The Village at Timbergate Unit 1, Block 1, Lots 4-12 (Final Plat)

Request for Plat Waiver From the Street Dedication Requirement

Planning Commission Meeting August 21, 2019

Final Plat: Unit 1, Block 1, Lots 4-12

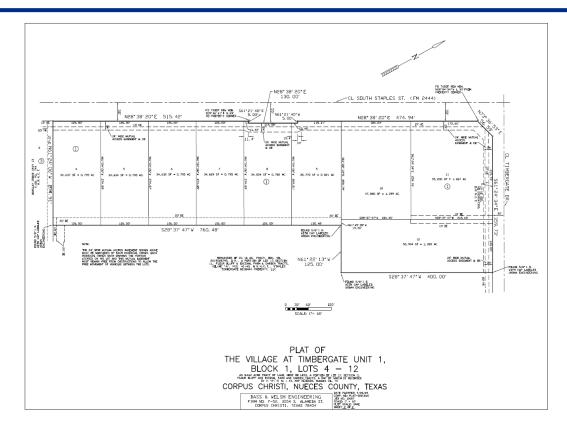
Final Plat 1/2 ROW: Less than 65 feet

Right-of-Way Widths (approx.)

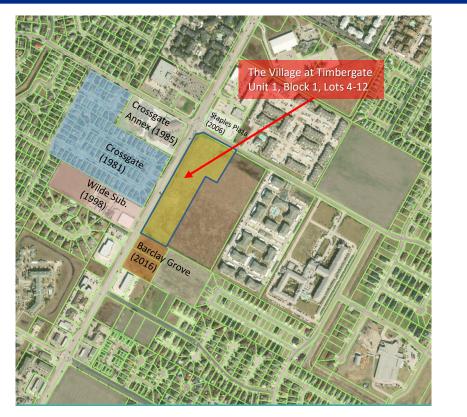
Right Turn Lane

- Staples Plaza (2006), north of Timbergate, additional ROW acquired to achieve 130'
- Barclay Grove (2016), south of site, is mid-block, over 1,000 feet from collector
- ROW west of center line is greater than ROW east of center line
- Sidewalk on east side of Staples might not be in ROW (+5 feet)
- Right-turn lane into this commercial subdivision would relieve stacking congestion (+10 feet)
- Right-turn lane from Staples onto Timbergate advisable (similar to what's already at NW corner)

Staff recommends denial of the request for waiver from the street right-of-way dedication requirement
